ADDENDUM NO. 2

RFP #22-53

Valve and Finished Water Tank & Reservoir Improvements

PROJECT NO.
211162
SHEET NO.

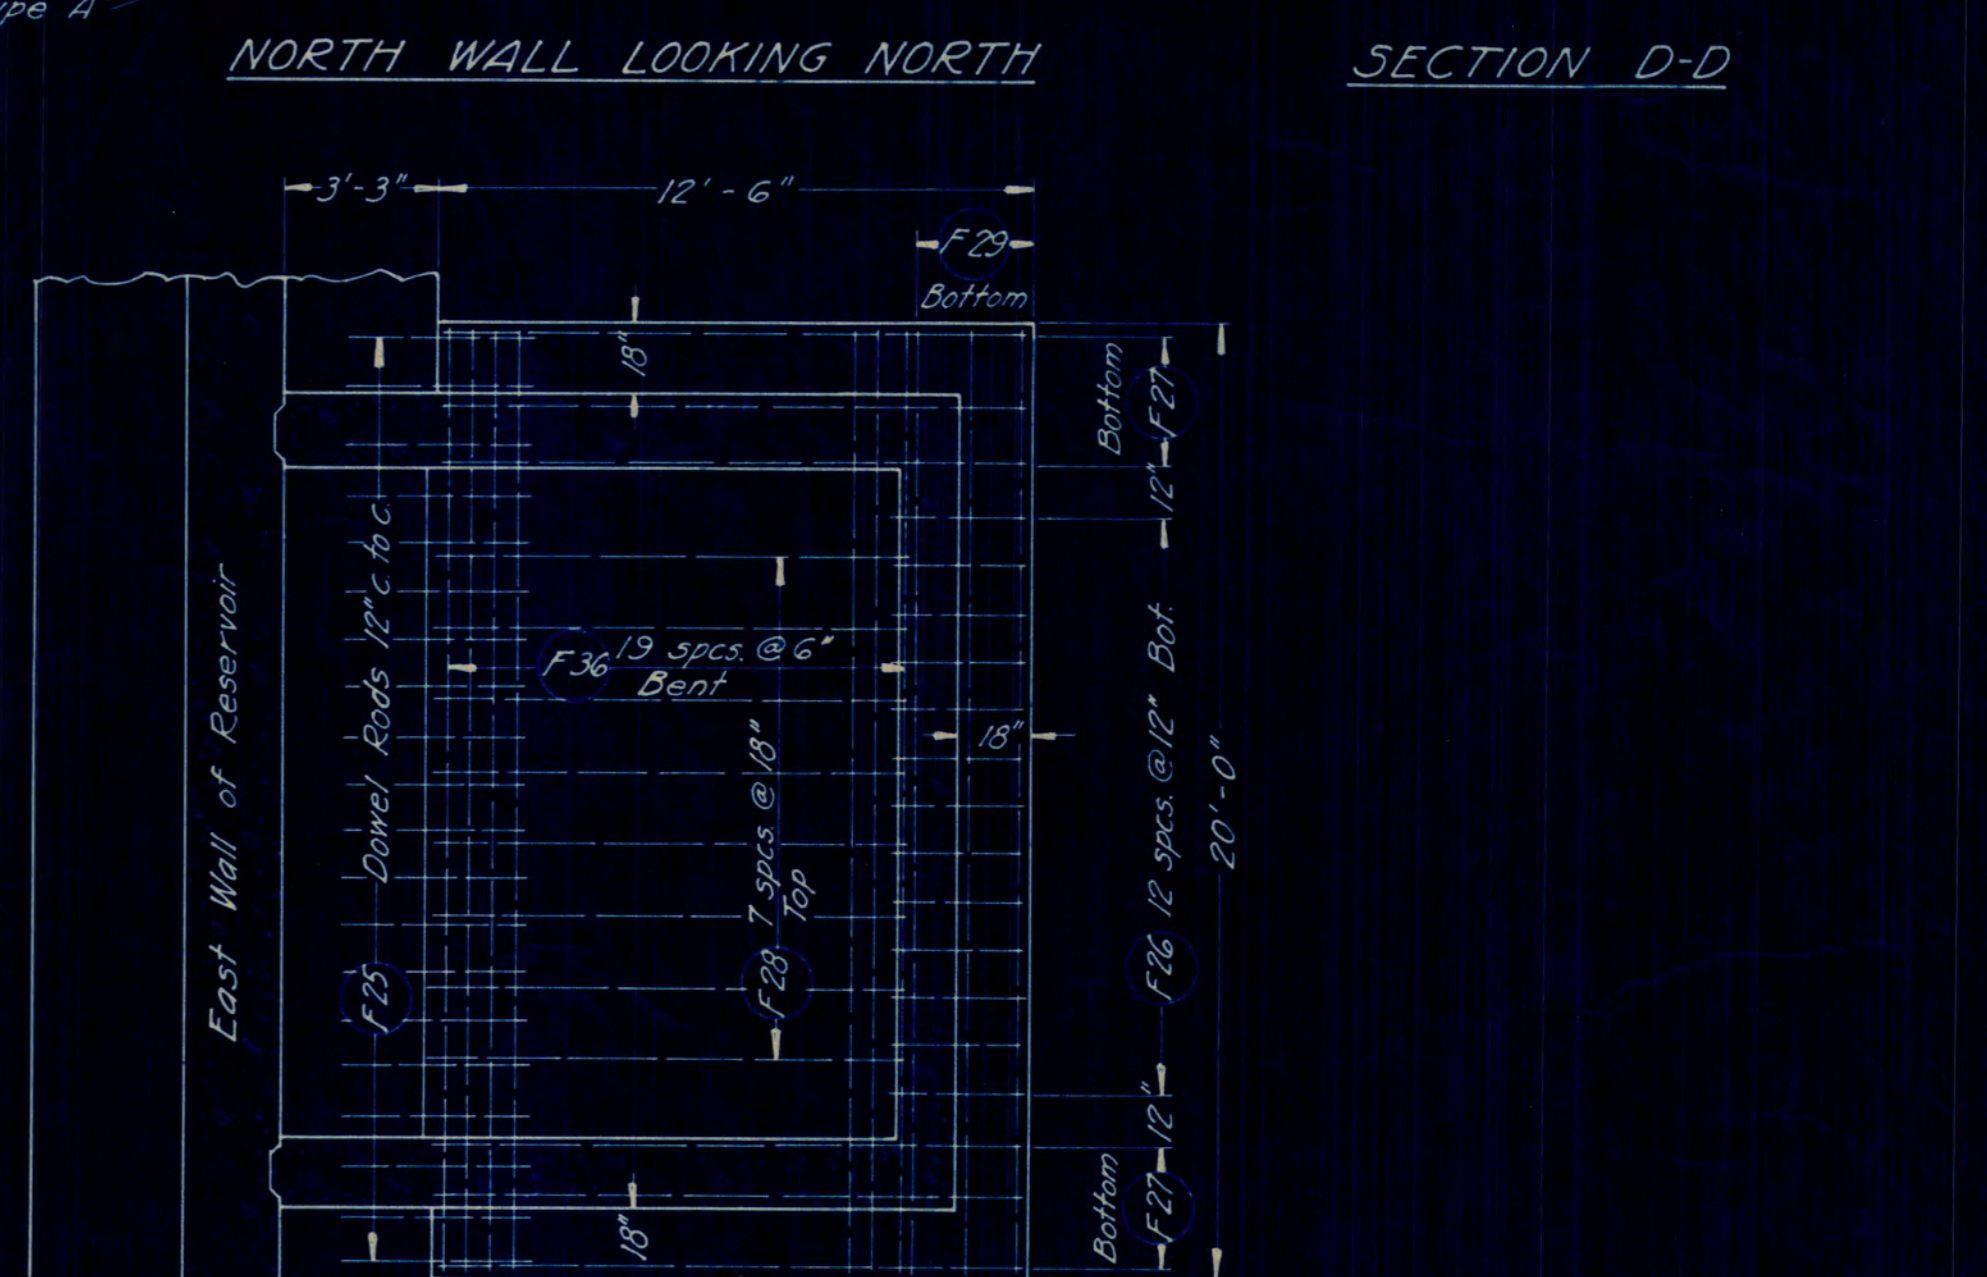
- Q: Note 2 on drawing 7 refers to a detail for the new grating supports but no such detail is provided. Please provide detail.
- A: Details included on reissued sheet 7.

- KEY NOTES**
- 30" BUTTERFLY VALVE.
 - INSTALL PAINTED, GALVANIZED W8X10 GRATING SUPPORTS ACCORDING TO THE DETAIL THIS SHEET AND TO MATCH THE LAYOUT THAT WAS FIELD VERIFIED. INSTALL PAINTED, GALVANIZED W8X10 SUPPORTS AT ENDS OF GRATING AT PENETRATIONS, AND FRAME BACK TO GRATING SUPPORTS SPANNING ACROSS TRENCH. INSTALL PAINTED, GALVANIZED L5X3X1/4 ACCORDING TO THE DETAIL THIS SHEET AT EACH END OF THE TRENCH. ENSURE ENDS OF GRATING SPANS WILL BE SUPPORTED AND THAT GRATING DOES NOT SPAN MORE THAN 4- FEET. INSTALL SALVAGED GRATING ON NEW SUPPORT SYSTEM AND ANCHOR TO SUPPORTS WITH STAINLESS STEEL SADDLE CLIPS IN A CONFIGURATION THAT PERMITS GRATING TO BE REMOVED IN THE FUTURE.
 - 24" PIPING.
 - 24" COUPLING.
 - 30"x24" REDUCER.

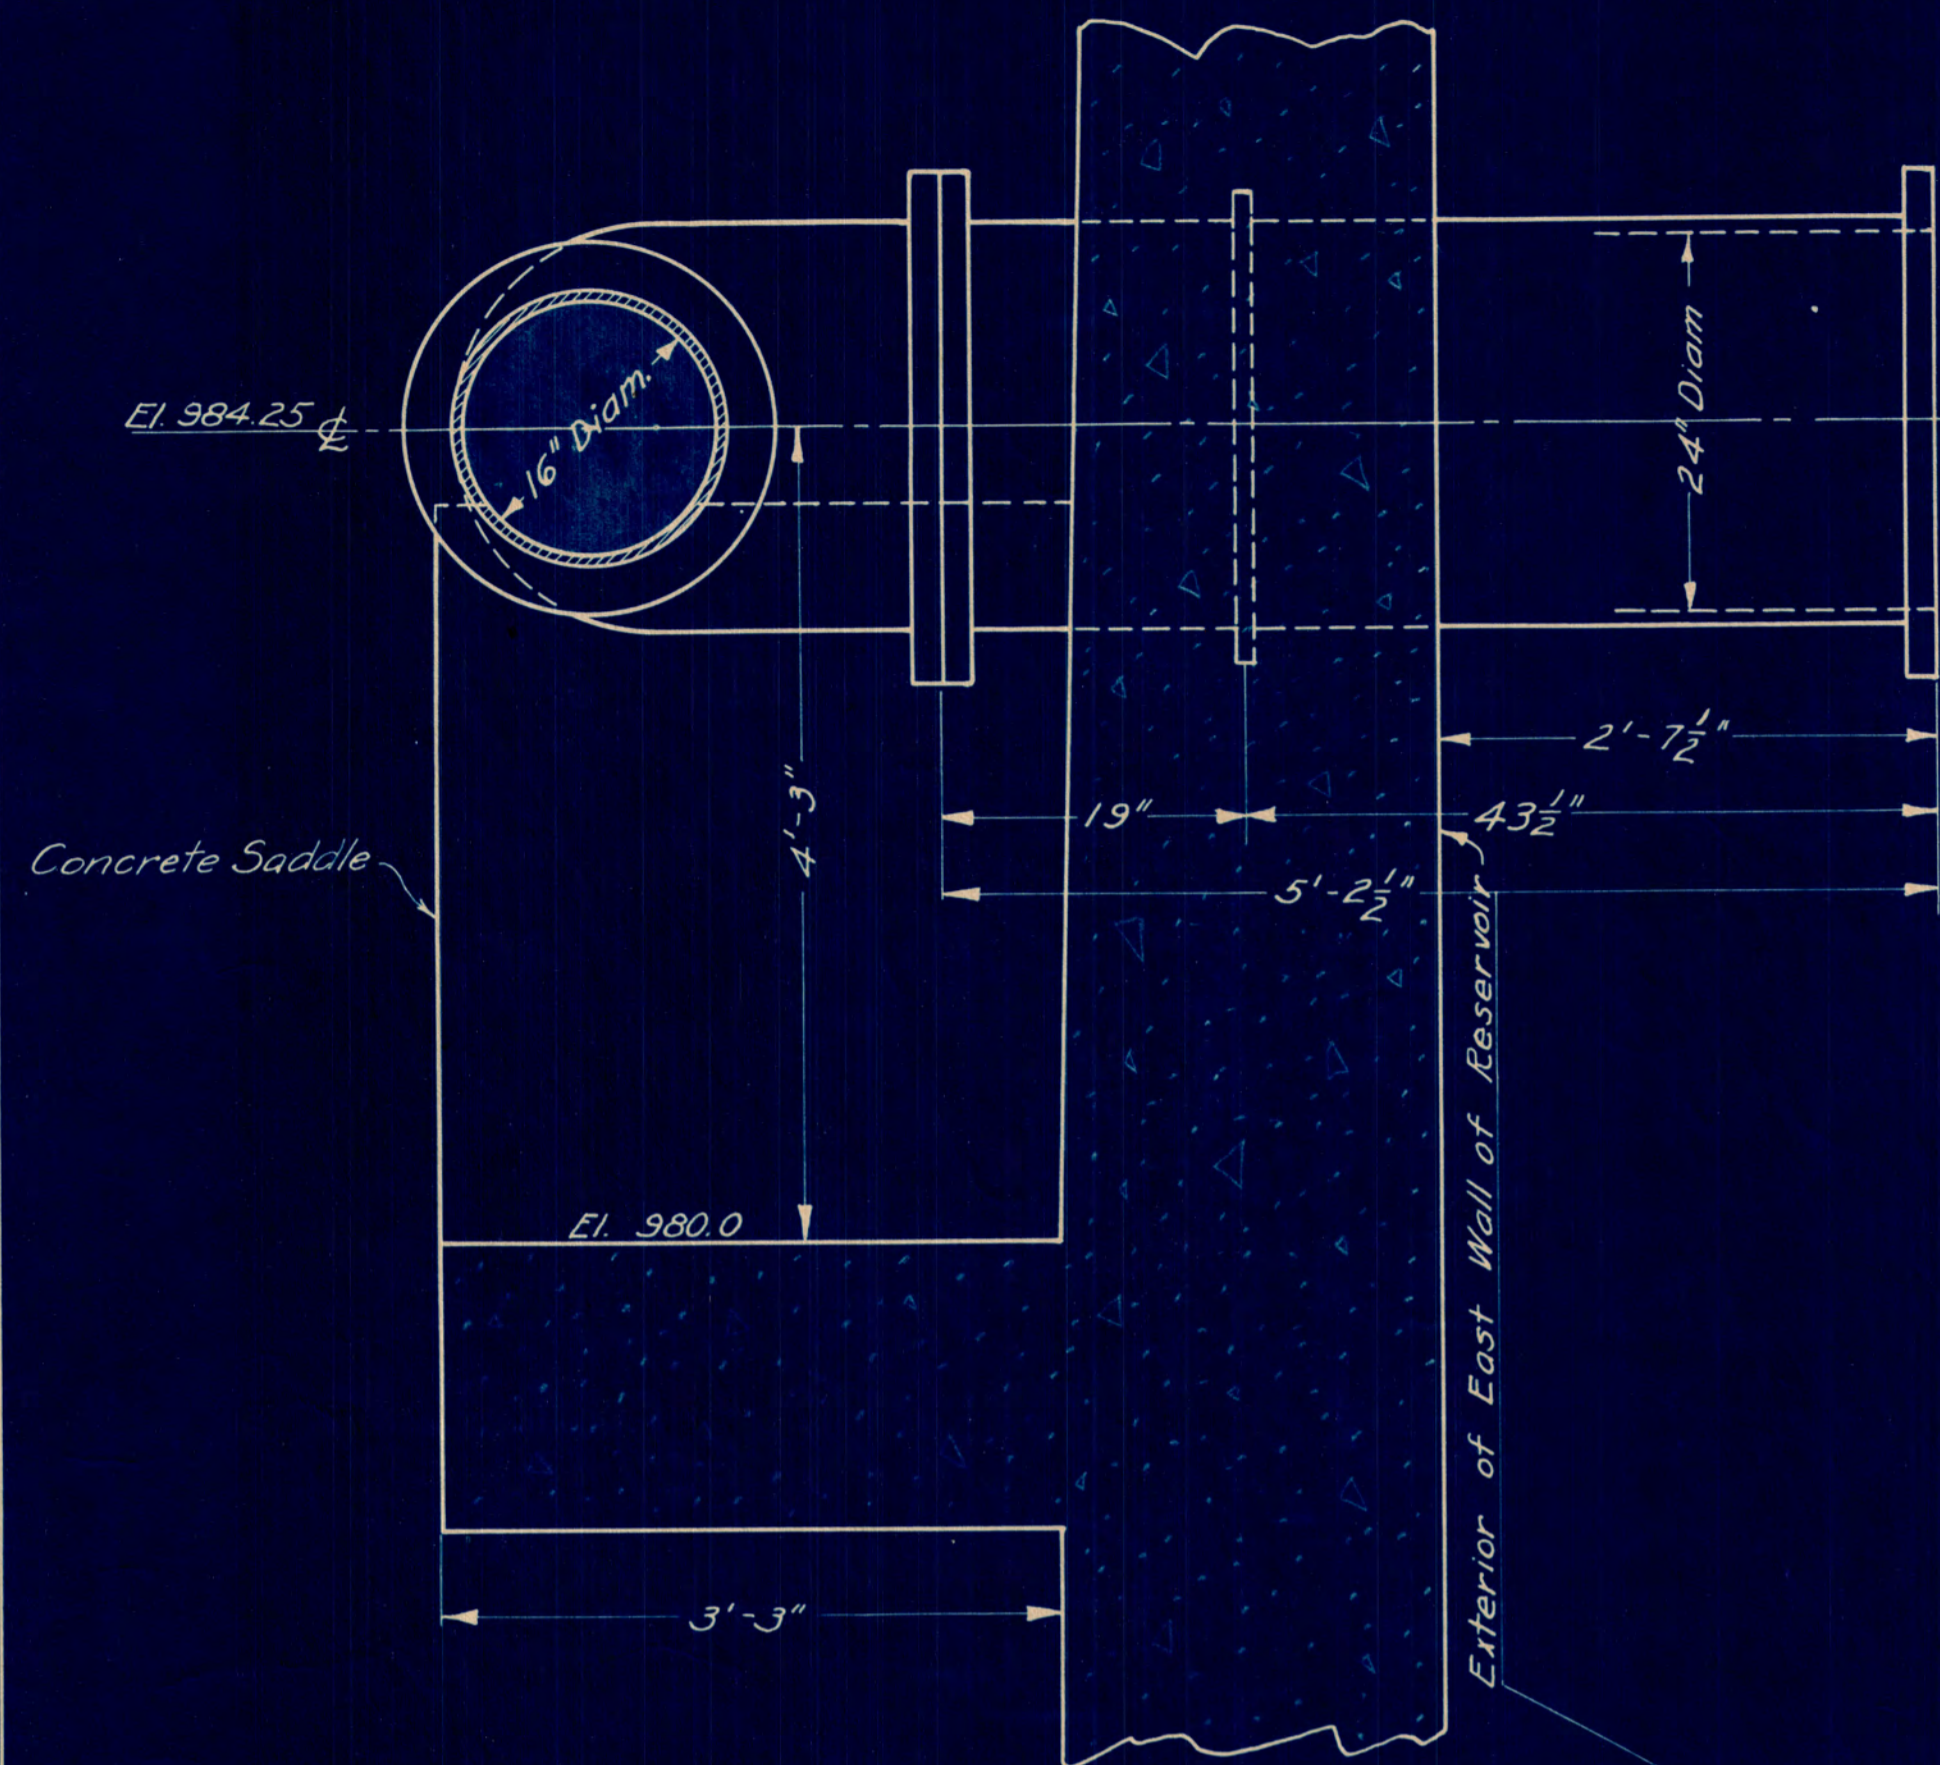
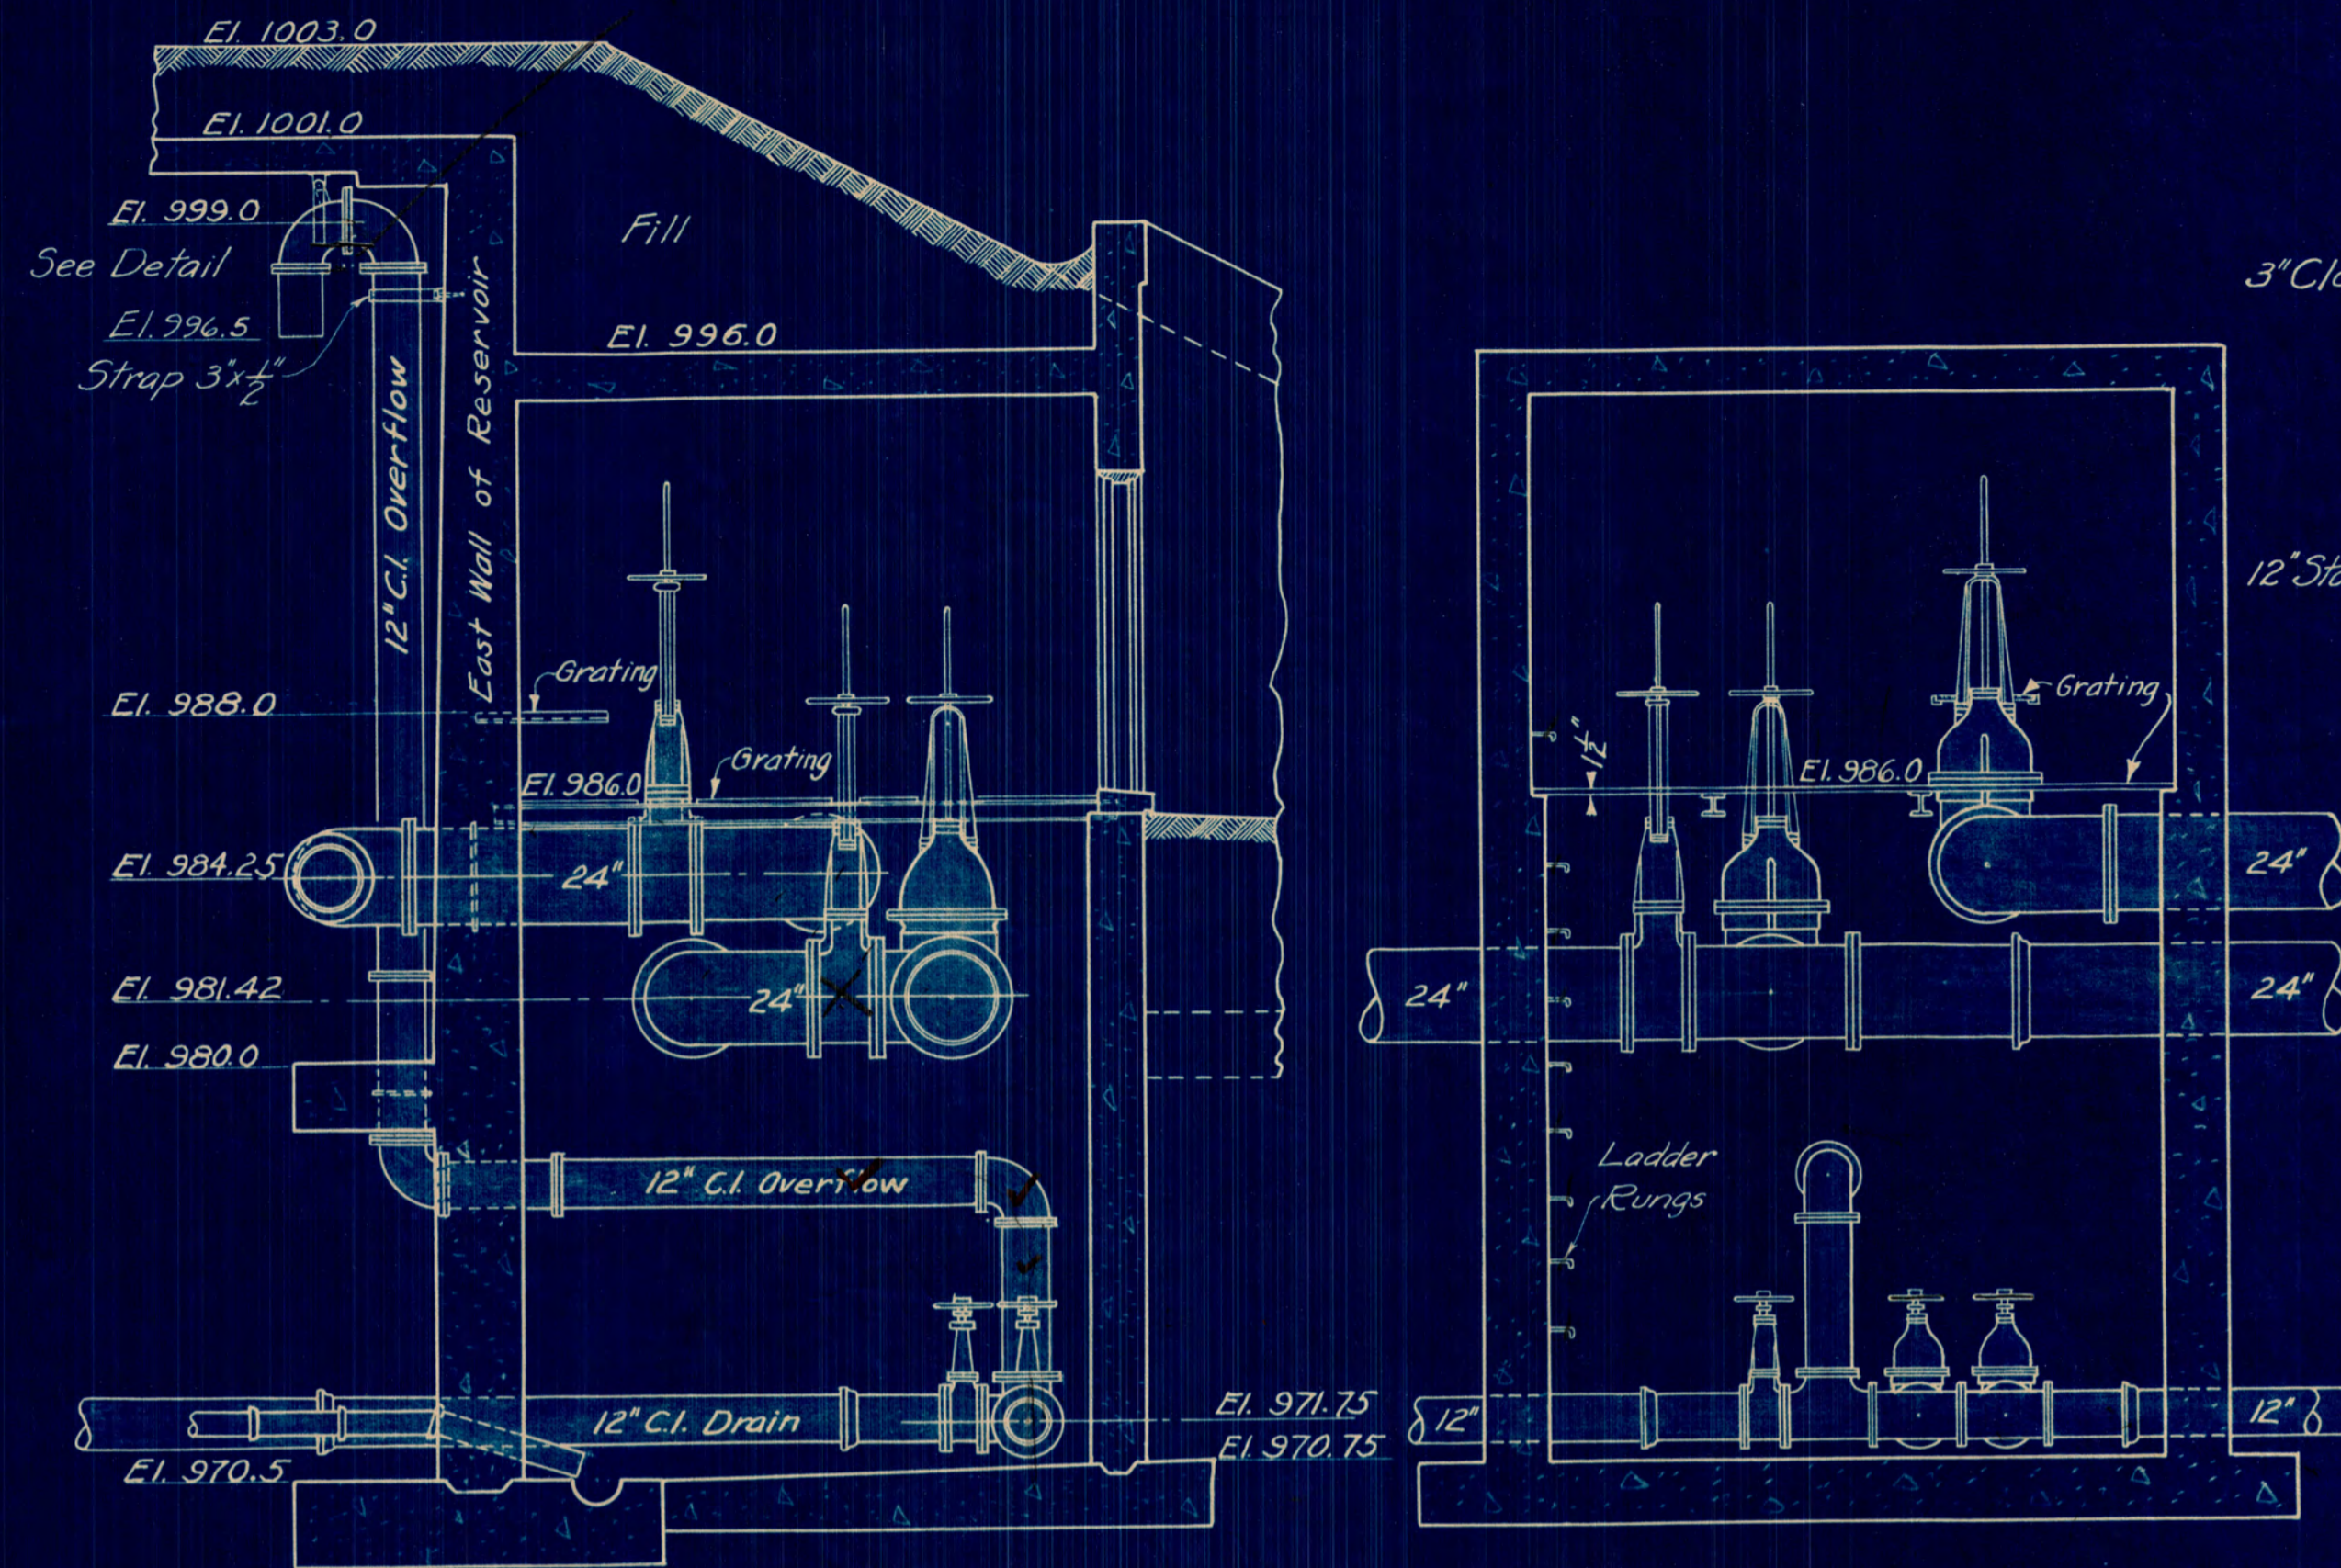
- Q: Notes 3 and 5 on drawing 13 indicates that new supports may be required to support the new grating. Please provide details regarding the existing grating supports so we can evaluate the potential need for additional supports prior to submitting a bid. If new supports are required, will this be considered extra work or incidental to base bid?

- Q: How is the interior of the existing valve vault shown on drawing No. 12 accessed? Drawing No. 12 does not show an opening. What is the size of the Opening and will it support the installation of new grating? Please provide a layout plan and details for the existing Grating supports referenced in note Nos. 3 and 5 shown on drawing Nos. 12 and 13, respectively.
A: See attached record drawings.

- A: See attached record drawing showing existing grating supports in the Vault House. Existing supports should be sufficient, however the age of the structure and lack of a clear condition assessment due to the locations of the supports is uncertain. Repair or replacement of supports would be additional work paid for through the allowance.
